McGUIRE NUCLEAR STATION, UNIT 1

AMENDMENT TO FACILITY OPERATING LICENSE

Amendment No. 162
License No. NPF-9

Replace the following pages of the Appendix "A" Technical Specifications with the enclosed pages. The revised pages are identified by Amendment number and contain vertical lines indicating the areas of change.

Figure 3.4-2

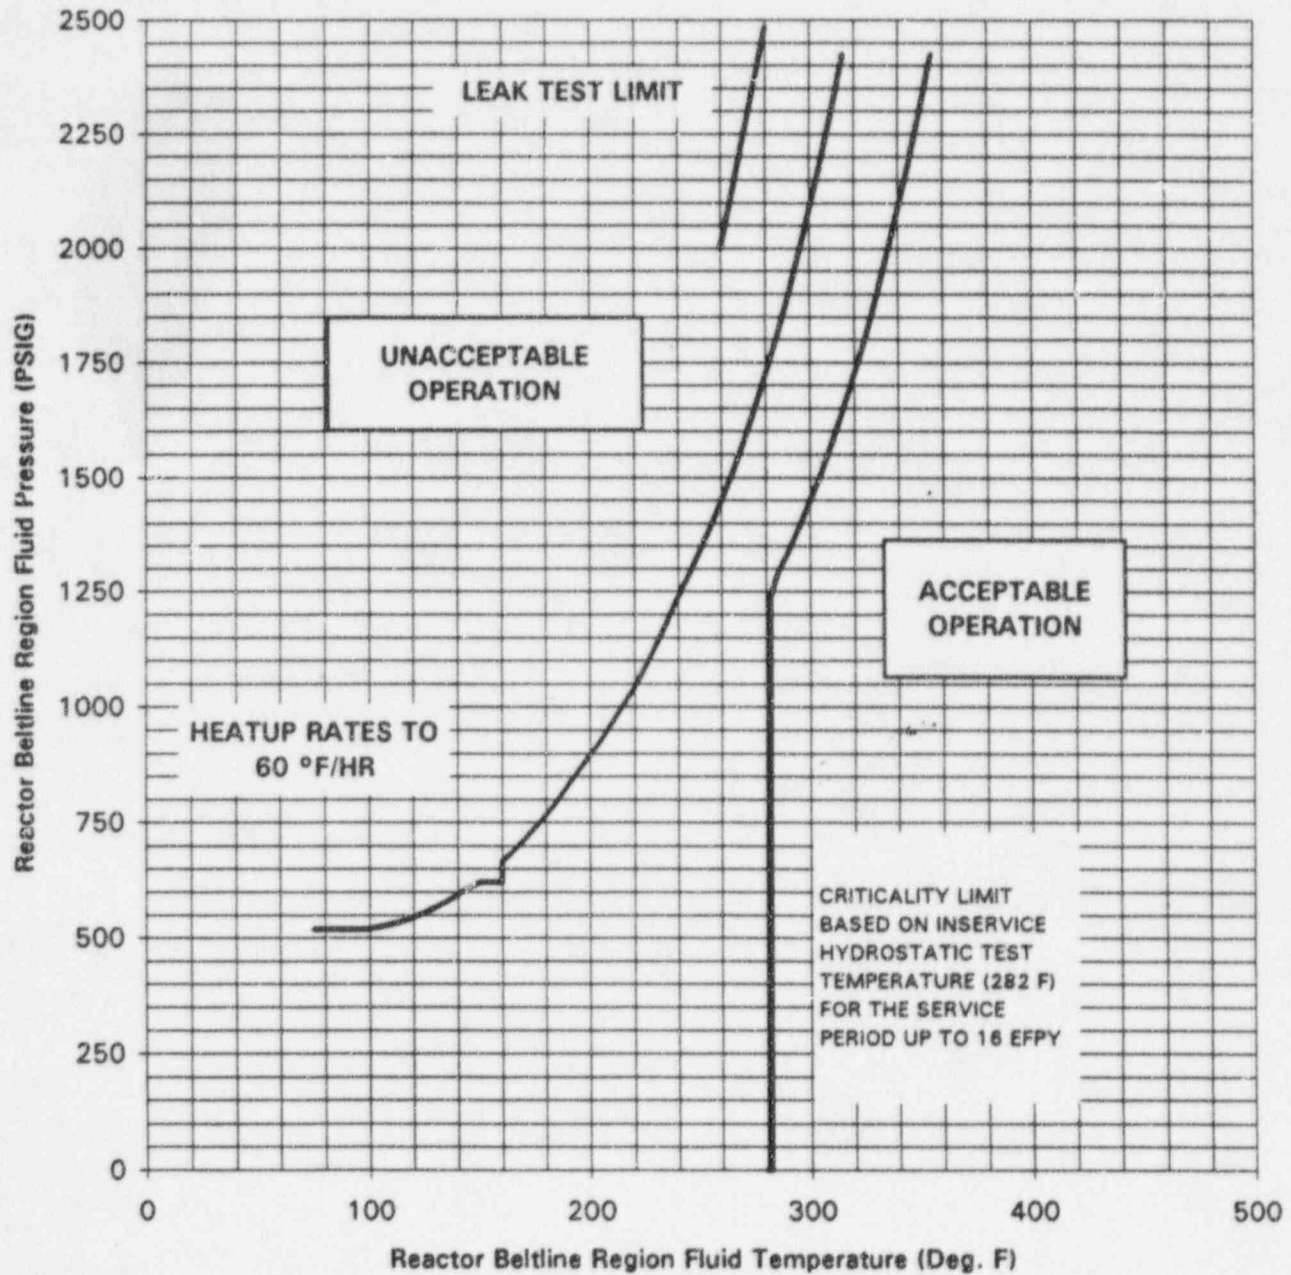
LIMITING MATERIALS: LOWER SHELL LONGITUDINAL WELDS 3-442A and LOWER SHELL PLATE B5013-2

LIMITING ART AT 16 EFPY:

- 1/4-t, 149.5 deg. F
- 3/4-t, 102.0 deg. F

McGuire Unit 1 Reactor Coolant System Heatup Limitations
(Without margins for Instrumentation Errors)
NRC REG GUIDE 1.99, Rev. 2
Applicable for the first 16 EFPY

Figure 3.4-3

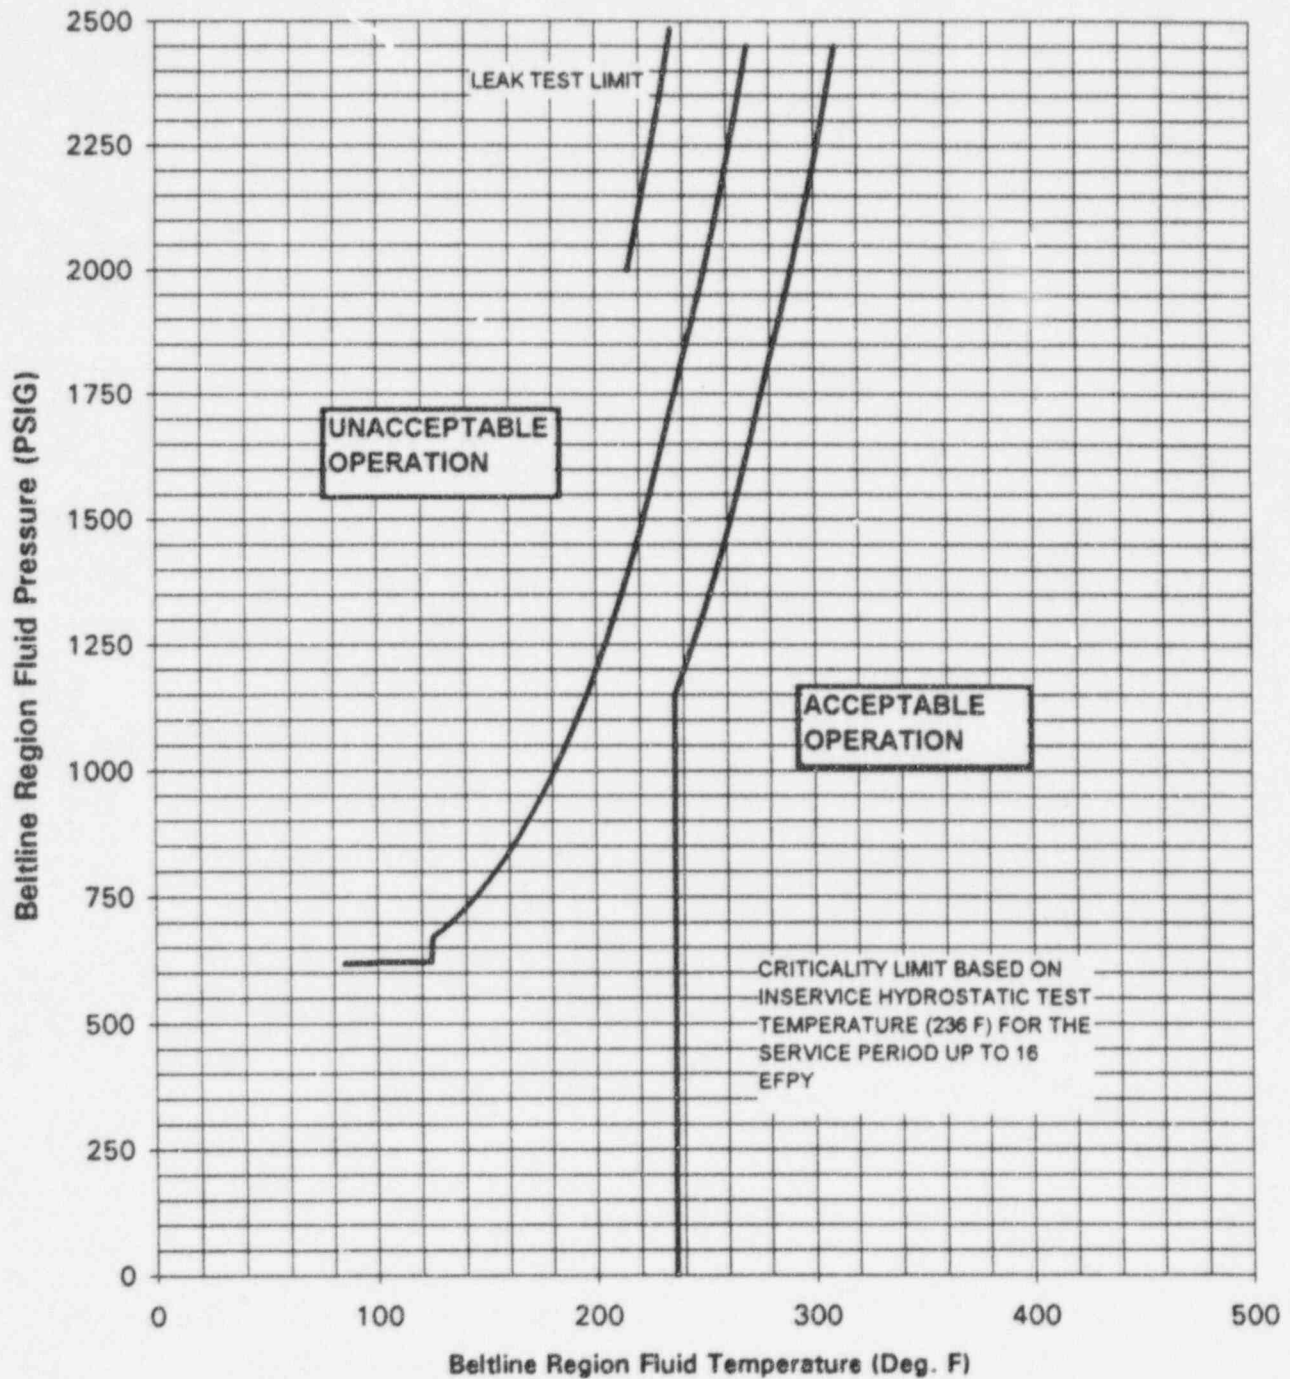
LIMITING MATERIALS: LOWER SHELL FORGING 04
 LIMITING ART AT 16 EPY:

1/4-t, 104 deg F
 3/4-t, 73 deg F

McGuire Unit 2 Reactor Coolant System Heatup Limitations
 (Without Margins for Instrumentation Errors)
 NRC REG GUIDE 1.99 Rev. 2
 Applicable for the First 16 EPY

Figure 3.4-4

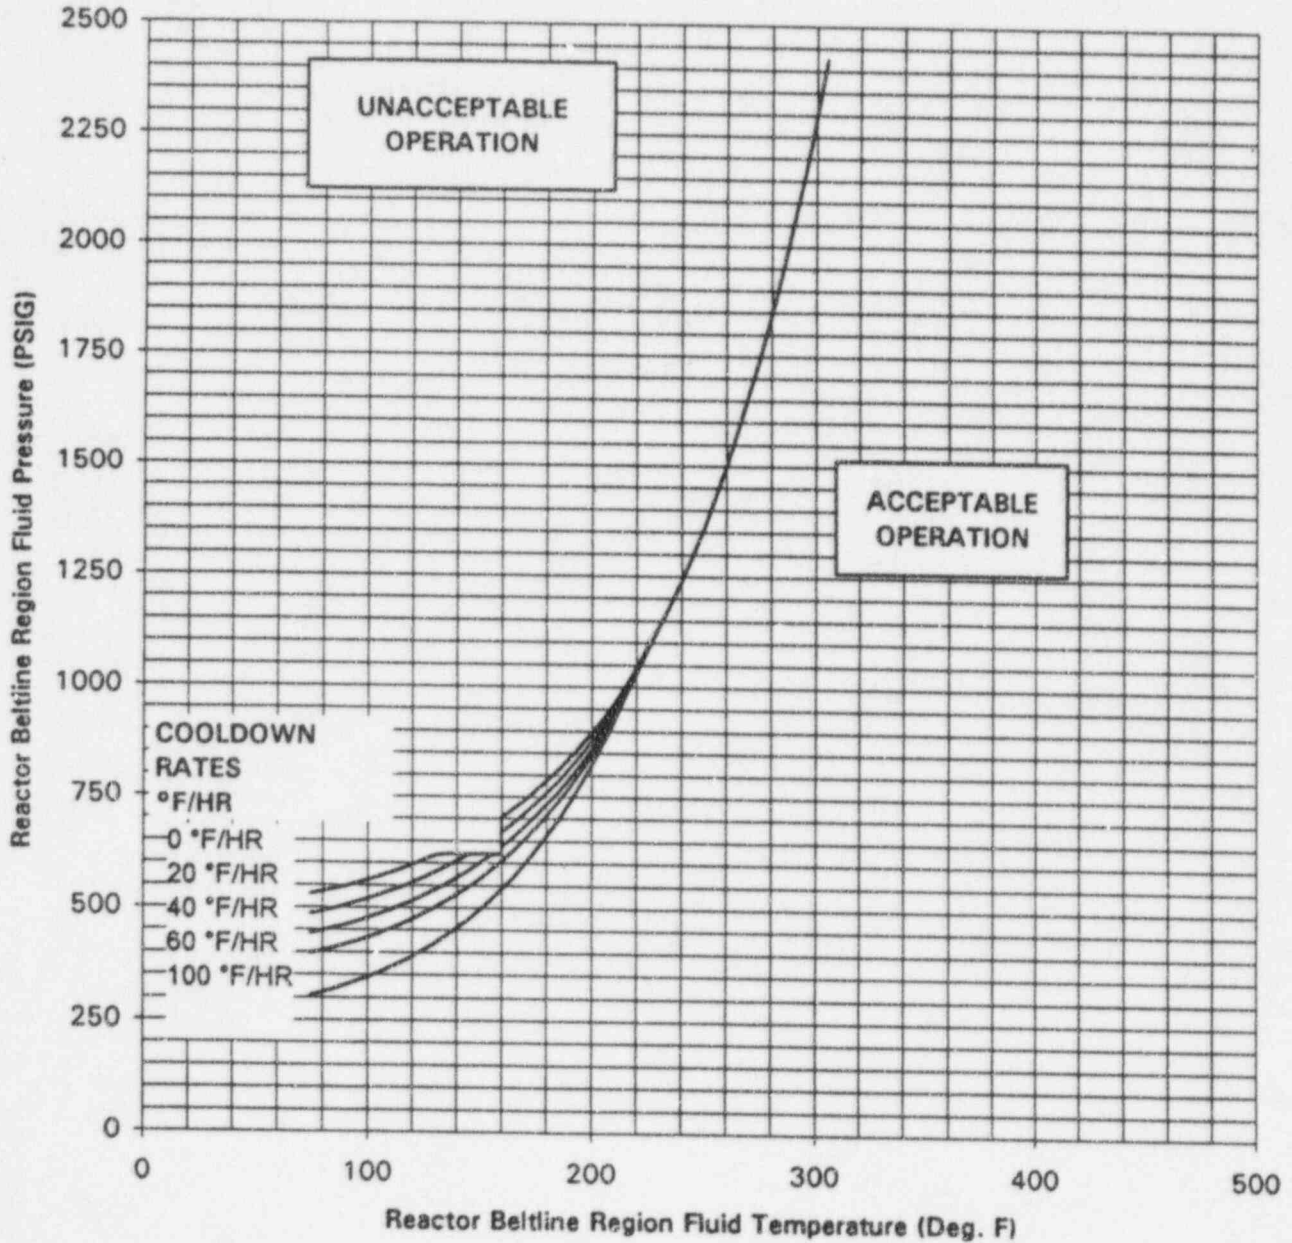
LIMITING MATERIALS:

LOWER SHELL LONGITUDINAL WELDS 3-442A and
 LOWER SHELL PLATE B5013-2

LIMITING ART AT 16 EFPY:

1/4-t, 149.5 deg. F
 3/4-t, 102.0 deg. F

McGuire Unit 1 RCS Cooldown Limitations,
 Cooldown Rates up to 100 deg. F/HR
 (Without Margins for Instrumentation Errors)
 NRC REG GUIDE 1.99, REV. 2
 Applicable for the First 16 EFPY

McGuire Unit 2 RCS Cooldown Limitations,
 Cooldown Rates up to 100 deg F/HR
 (without Margins for Instrumentation Errors)
 NRC REG GUIDE 1.99, Rev. 2
 Applicable for the First 16 EPFY

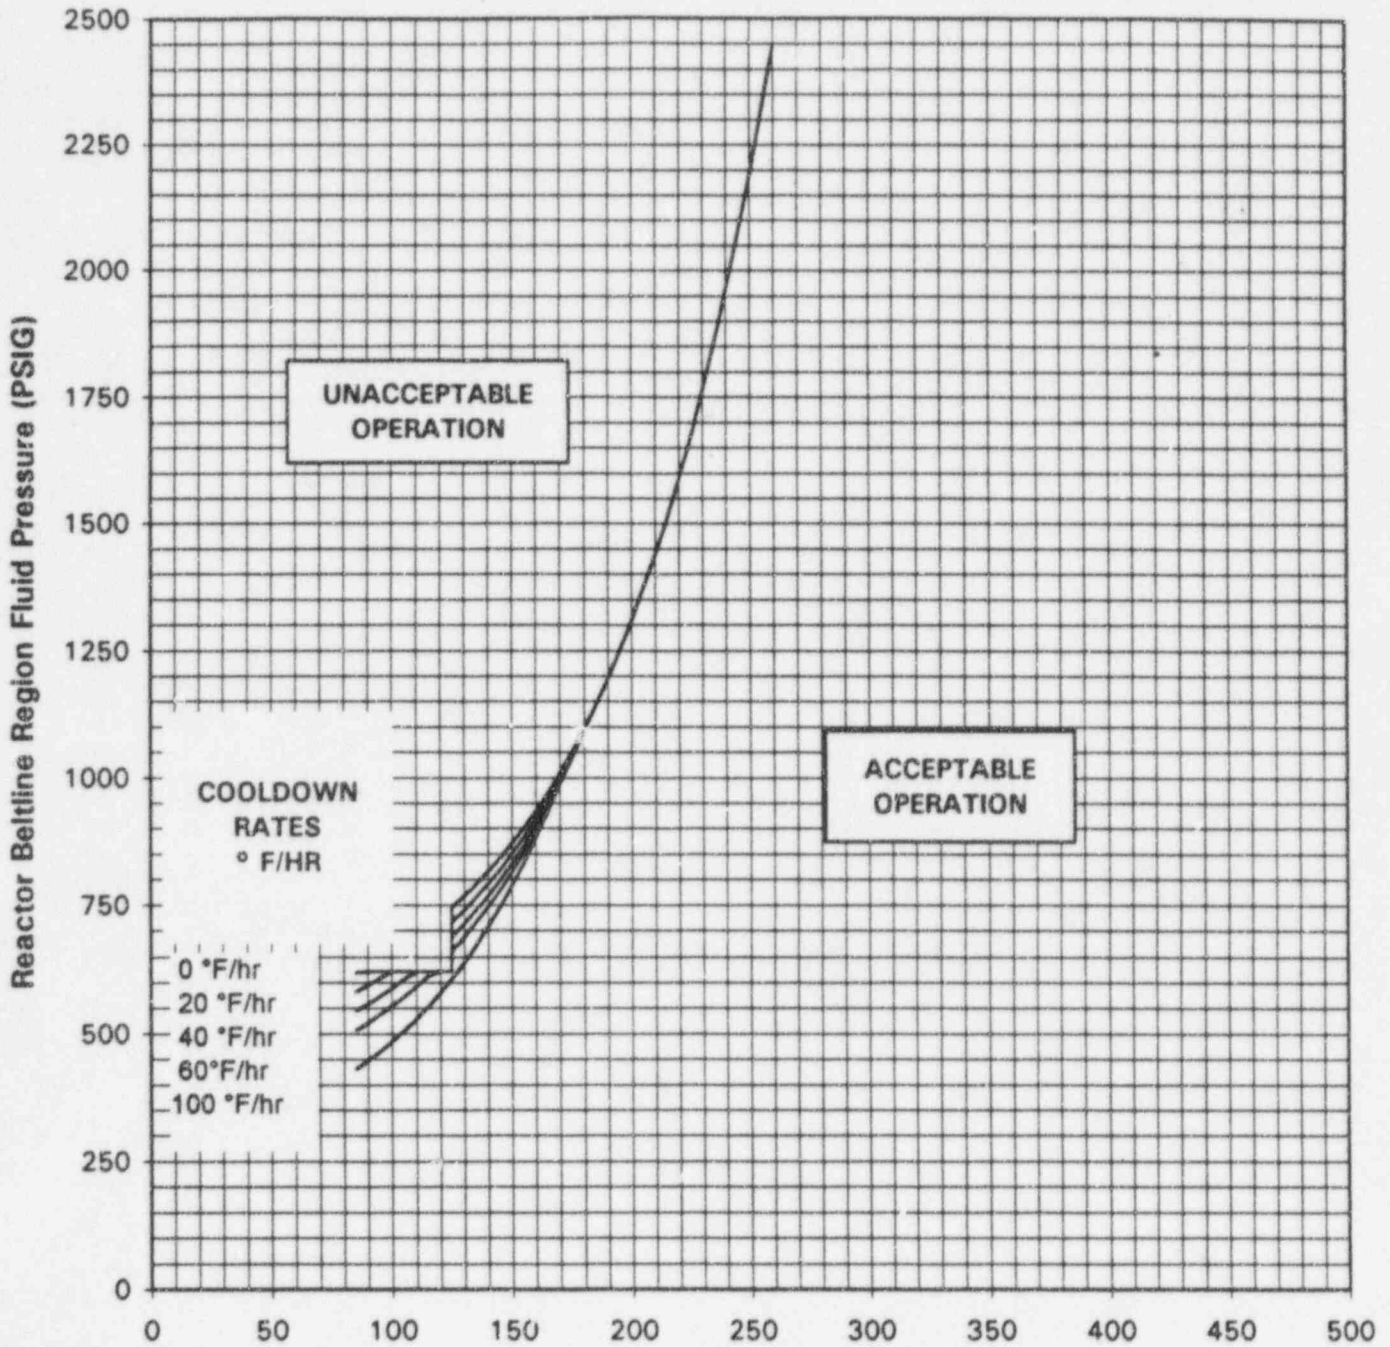
LIMITING MATERIALS: LOWER SHELL FORGING 04

LIMITING ART AT 16 EPFY:

1/4-t, 104 deg F

3/4-t, 73 deg F
